CHAPTER 2 PUBLIC COMMENTS AND RESPONSES

The Board's Section of Environmental Analysis (SEA) received 25 comment letters during the public comment period on the EA.¹³ This section summarizes the comments from the public and various local and state agencies and presents SEA's responses. SEA prepared the responses to comments in accordance with CEQ guidance. The guidance provides that "if a number of comments are identical or very similar, agencies may group the comments and prepare a single answer for each group. Comments may be summarized if they are especially voluminous."¹⁴

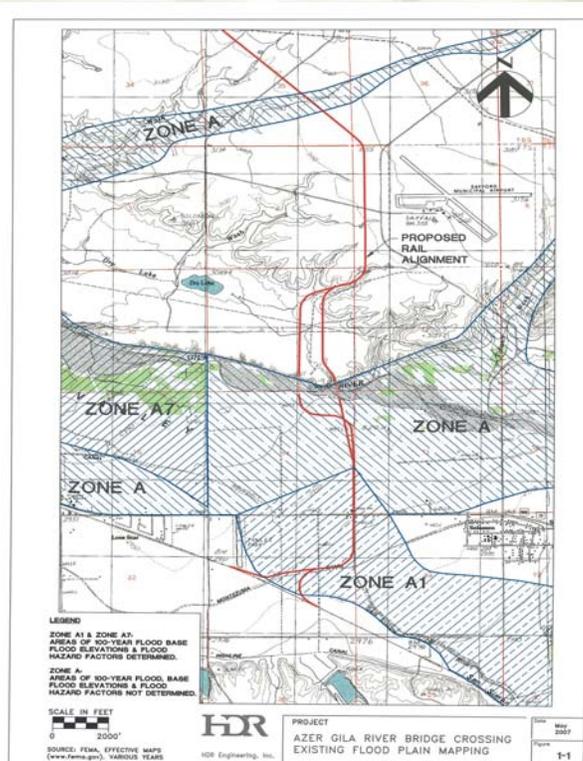
The pre- and post-project floodplain model should be included in the EA to determine the impact of the project on the floodplain.

Comment

FEMA publishes “Flood Insurance Rate Maps” or FIRMs for the entire United States. These maps show the locations of flood hazard areas, including areas estimated to flood at 100 or 500 year intervals. The hydrological study for the Proposed Action was based upon careful review of the FEMA FIRM map for the area. The Draft EA specifically mentioned that the FIRM for the area indicated that the proposed alignment would traverse areas of floodplains associated with the San Simon and Gila Rivers. For the greater convenience of readers, a map of the floodplain areas is shown in the figure at right.

Proposed extension of taxiway and new runway

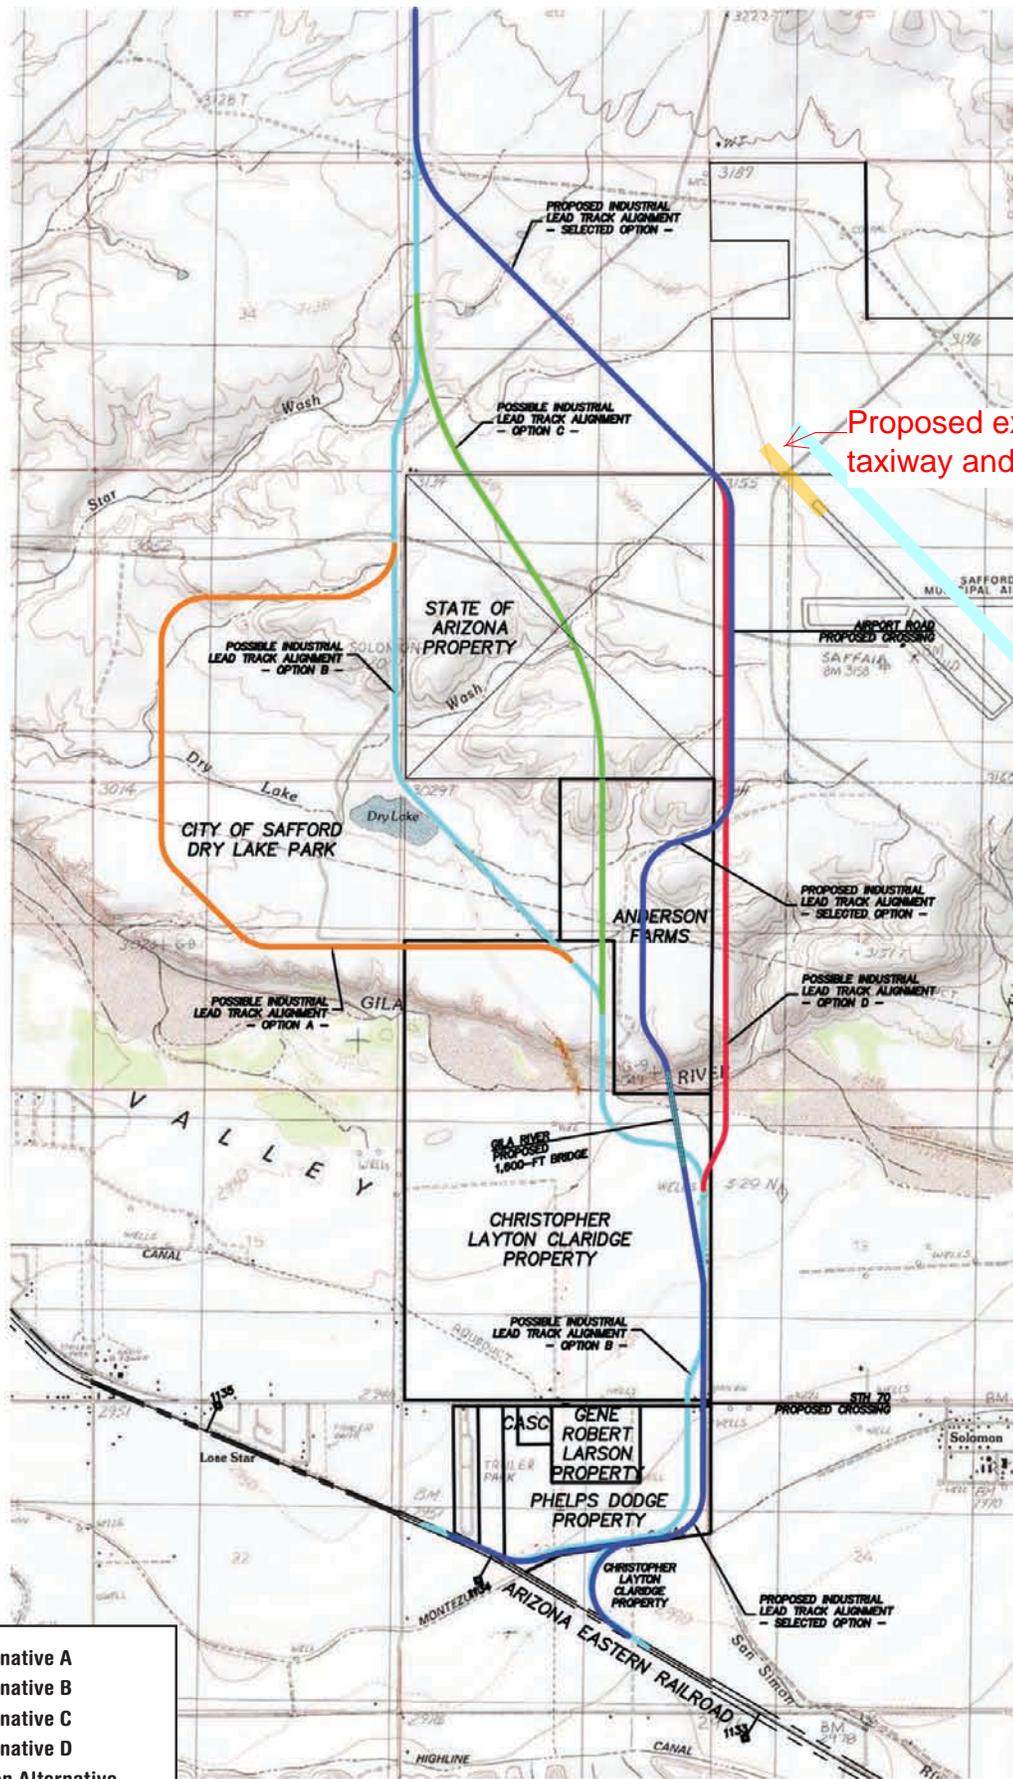
SEA should discuss plans for the proposed alignment with the City of Safford so that the proposed rail line does not conflict with existing and future development and land uses, such as the Safford Regional Airport and Dry Lake Park.

feet in a northwesterly direction, within close proximity to the alignment of the proposed rail line. According to a diagram provided to SEA by the City of Safford (and included as Figure 1 in this Post EA), the existing taxiway A/B would be extended from 6,000 to 8,000 feet in length, and a new 8,000 foot runway would be constructed to the immediate north, parallel to the extended taxiway.

As shown in Figure 1 of this Post EA, the right-of-way for the Proposed Action turns sharply to the northwest near the Airport's northern boundary. Therefore, SEA has determined that the proposed rail alignment would not conflict with the proposed taxiway extension and new runway.
